<b>XtremeAir GmbH, Harzstr.2, D-39444 Hecklingen</b> Tel: +49 39267 60999 0, Fax: +49 39267 60999 20 www.xtremeair.de info@xtremeair.de	Document No. <b>SB-2015-001</b>
		Issue: A.00
DOA-Nr.: EASA.21J.360	<b>Service Bulletin</b>	Date: 15.01.2015

Subject: Wing main spar bolts markings

Aircraft type affected: XA41-XA42

Figure 1: Main bolt marking location and content

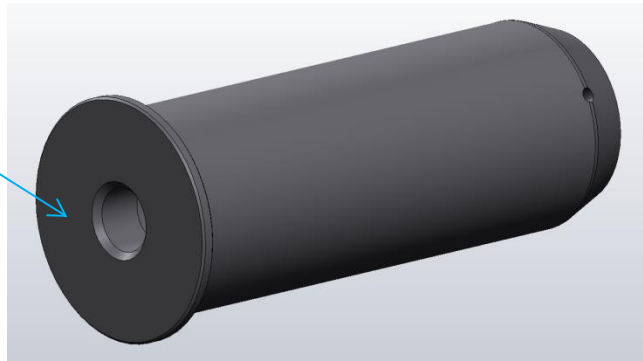
1. Remove the foot covers inside the cockpit, in front of the wing spar.
2. Access the front of the main spar bolts and check for markings.
3. If markings are missing, mark the bolt head with the permanent marker with the information in Figure 1.
  - a. The serial number for each bolt is given in Table 1 according to the serial number of the aircraft.
4. Reinstall the foot covers.

XtremeAir  
XA42-5320-250 A.01  
(Bolt s/n from Table 1)
